**To:** Design and Landmarks Committee  
**From:** Li Alligood, Associate Planner and DLC Liaison  
**Date:** June 25, 2012  
**Subject:** Preparation for July 2, 2012, Meeting

- 5.0 Public Meetings** – Public meetings will follow the procedure listed on reverse
  - 5.1 Summary: Design Review of PMLR Signal & Communications Building (DR-12-05)  
Presenters: Li Alligood, Associate Planner

Recommend that the Planning Commission approve application DR-12-05 with the recommended Findings and Conditions of Approval found in Attachments 1 and 2. This action would recommend approval of a design for a signal and communications building as part of the Portland Milwaukie Light Rail (PMLR) project in downtown Milwaukie.

SIGNAL/COMM BUILDING PLANS  
FLOOR PLAN, ROOF PLAN AND REFLECTED CEILING PLAN

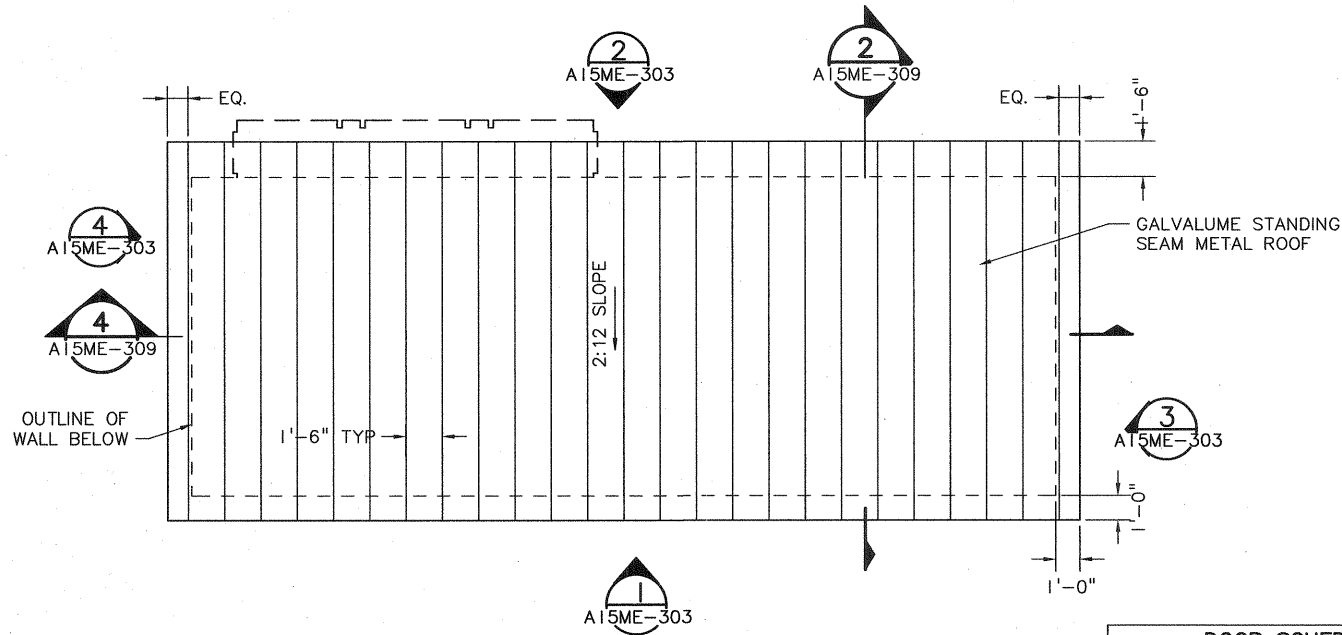
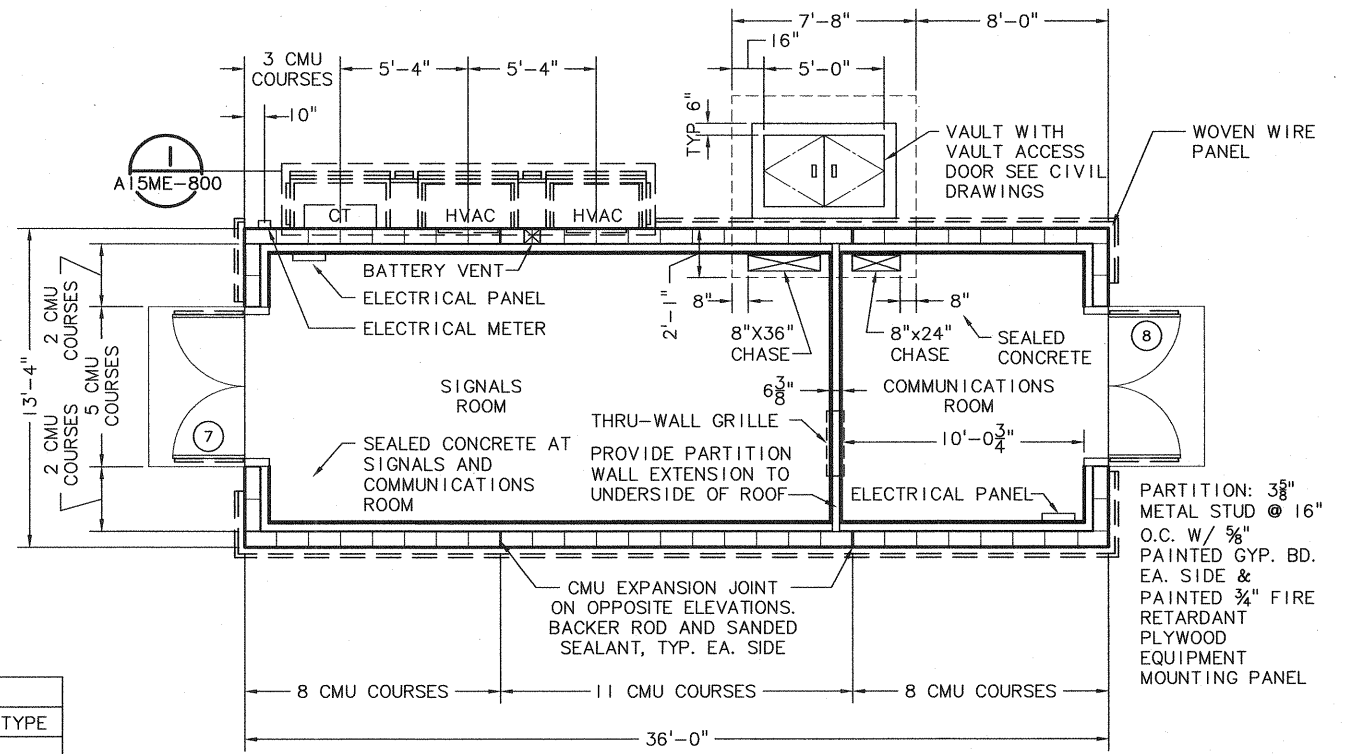
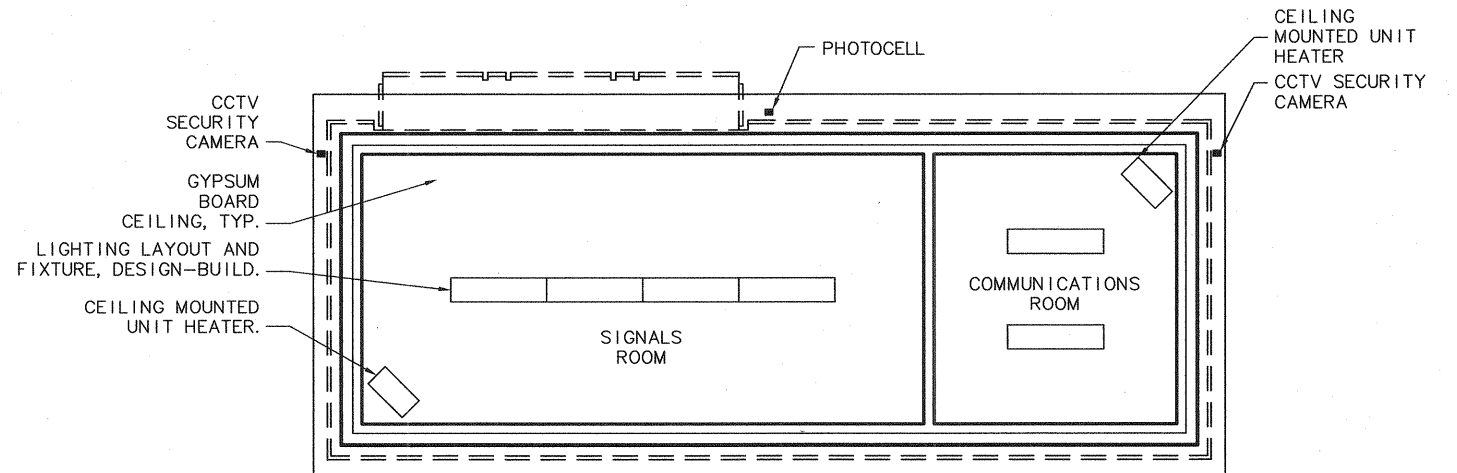
The downtown design standards for roofs require that buildings with flat roofs (roofs with a slope of equal to or less than 2:12) include a cornice of at least 6 inches depth and 12 inches in height. The proposed building includes a roof with a slope of 2:12, which does not meet the minimum slope for a pitched roof. The applicant has indicated that a higher roof pitch would add more material and more visual mass to a design that is intended to be modest and unassuming, and that the roof design is therefore integral to the overall design concept.

In combination with the design guidelines related to roofs (“Silhouette and Roofline” and “Rooftops”), the intent of the cornice requirement for flat roofs is to ensure that rooftop mounted mechanical equipment is screened from street-level view, as well as to provide a decorative visual “cap” to a sheer wall. In the case of a projecting cornice, the cornice protects the face of a building from rain. The proposed building does not include any roof-mounted mechanical or other equipment, and it is not necessary to hide these components from view. The proposed roof design includes 12-inch eaves to protect the building from the weather, and a cornice is not necessary for this function.

- i) The modification is integral to the overall design concept of the building.  
 The requested modification would allow for the use of a flat roof with a 2:12 pitch. The minimally sloped roof design is clean and modern, and allows the roof to visually recede. The use of a cornice on the roof would be visually unappealing and inappropriate.

- ii) The modification substantially meets the intent of the design standard either individually or in combination with other design elements of the project.  
 The intent of the design standard, in combination with the architectural design guideline regarding roofs, is to ensure that rooftop mounted mechanical equipment is screened from street-level view and that the building wall is finished with a visual "cap." The proposed structure does not include any roof-mounted mechanical or other equipment, and it is not necessary to hide these components from view. Additionally, the building design includes 12 inch eaves, which provides a finished appearance.

**PORTLAND MILWAUKIE LIGHT RAIL**  
 EAST SEGMENT **Exhibit P14**  
 SIGNAL/COMM BUILDING - ELEVATIONS

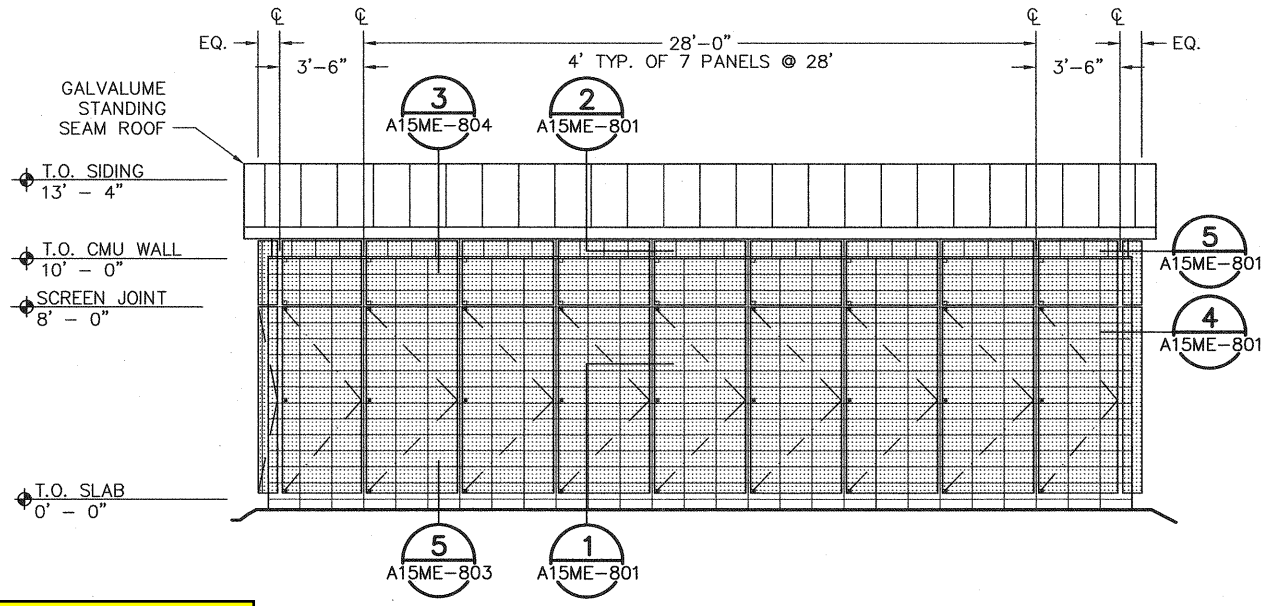
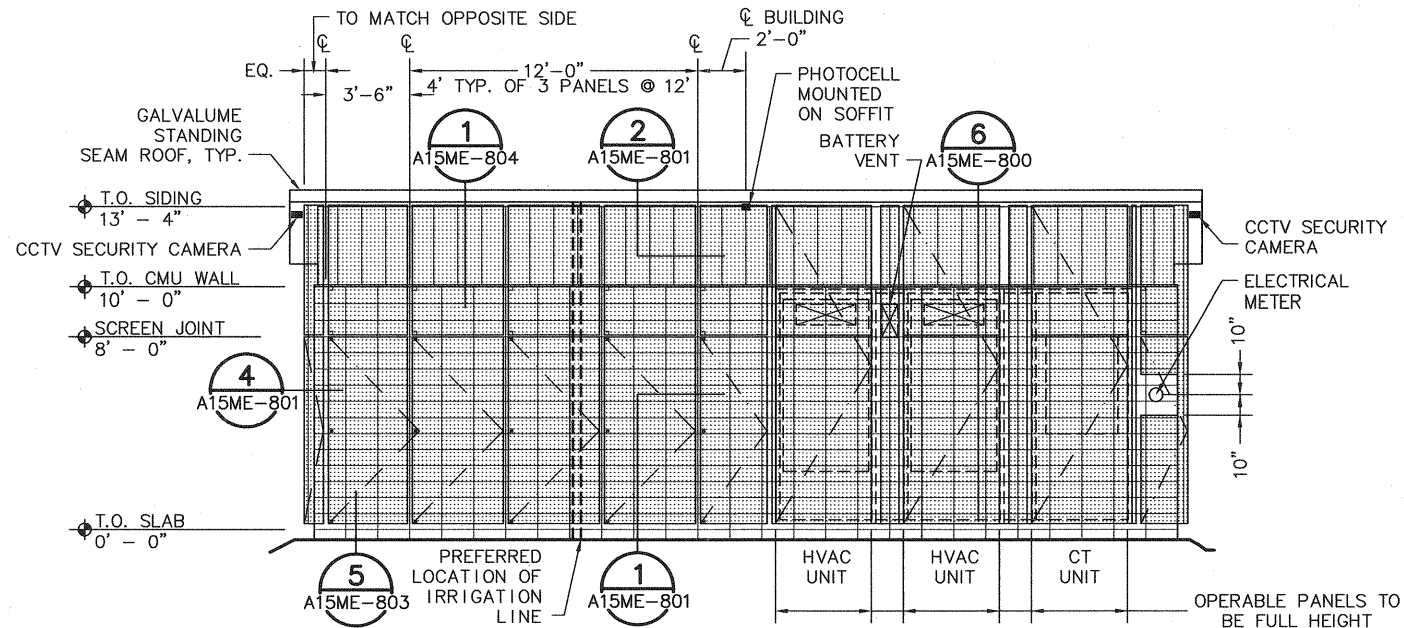
The proposal for the building includes the use of prohibited wall materials,<sup>4</sup> specifically masonry block (CMU), woven metal cladding, and metal panels. In order to use prohibited materials in the downtown zones, the applicant must show that the prohibited materials are substantially comparable to allowed materials with regards to quality; appearance; style; architectural effect; and durability. The proposed materials must also be consistent with the design guidelines related to the pedestrian environment, specifically "Define the Pedestrian Environment," and walls, specifically "Wall Materials" and "Wall Structure."

The visual appeal of the structure could be improved through the use of a different paint color for the CMU block and metal panels, to provide additional contrast between the walls and the woven wire cladding mounted to the surface.
